Access Compliance Report

Public Rights-of-Way

(Curb Ramps)

Intersection ID: 10015396	Main Street: EASTWAY_DR	Cross Street: EASTWAY_CROSSING_DR	Location: SE
ADA ID: 27FAA3847641	Ramp Type: Perp	Initial Pass/Fail: Fail	Overall Compliance: No
Severity Score: 18.75			
Codes/Mitigation Info/Possible Solution		Field Measurements/Component Compliance

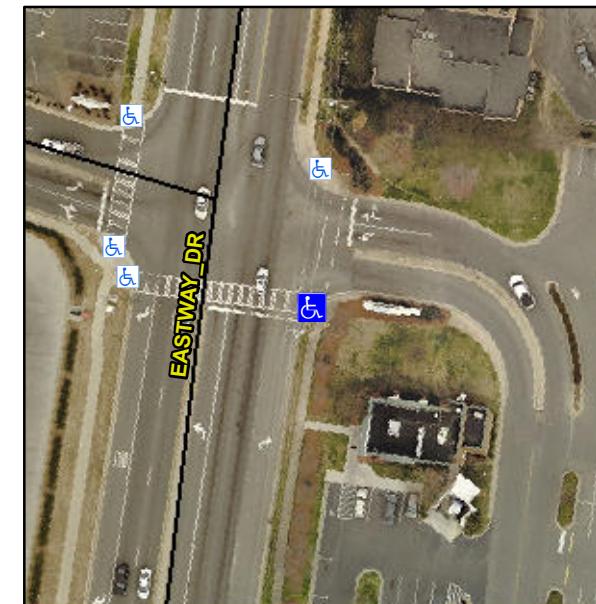
Not Found, R304.5.1

Compliance	Description	Data	Compliance	Description	Data
N/A	Ramp Length (in)	55.0	Yes	Ramp Slope (%)	7.9
No	Ramp Width (in)	33.0	Yes	Ramp XSlope (%)	4.3
N/A	Flare Type LT	N/A	N/A	Flare Type RT	N/A
N/A	Flare Slope LT (%)	N/A	N/A	Flare Slope RT (%)	N/A
N/A	Flare Traversable LT?	N/A	N/A	Flare Traversable RT?	N/A
N/A	Landing Length (in)	N/A	N/A	DWS Provided?	N/A
N/A	Landing Width (in)	N/A	N/A	DWS Contrast?	N/A
N/A	Landing Slope (%)	N/A	N/A	DWS Length (in)	N/A
N/A	Landing X Slope (%)	N/A	N/A	DWS Full Width?	N/A
N/A	Landing Curb? (Y/N)	N/A	N/A	DWS Offset (in)	N/A
N/A	Shared Landing?	N/A			
N/A	Gutter Ponding?	N/A	N/A	Gutter Slope (%)	N/A
N/A	Gutter Lip Ht (in)	N/A	N/A	Gutter X Slope (%)	N/A
N/A	Painted X Walk1?	Yes	N/A	Painted X Walk2?	N/A
	X Walk 1 Direction	To W		X Walk 2 Direction	N/A
N/A	X Walk 1 Width (in)	110.0	N/A	X Walk 2 Width (in)	N/A
	X Walk 1 Slope (%)	0.1		X Walk 2 Slope (%)	N/A
	X Walk 1 X Slope (%)	4.3		X Walk 2 X Slope (%)	N/A

Remove & Replace Entire Ramp.
